Access Compliance Report Public Rights-of-Way (Pedestrian Signals)

Signal Type: One Push Button-Non APS Severity Score: BTN 1:N/A BTN 2: N/A No BTN: N/A ADA ID: 22C4F36E06DB **Overall Compliance: No**

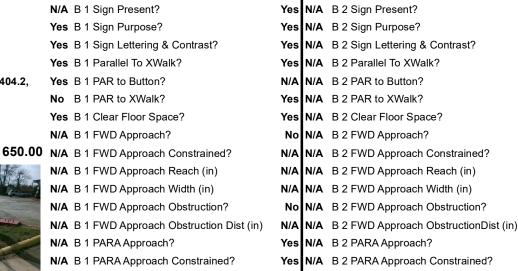
PROW/ADA: TMUTCD 4e.08, R404.3, R404.2, R404.7.3, R404.7.2

Possible Solutions: Replace Signal Push Button With APS Button on New Post. Remove & Relocate Sign.
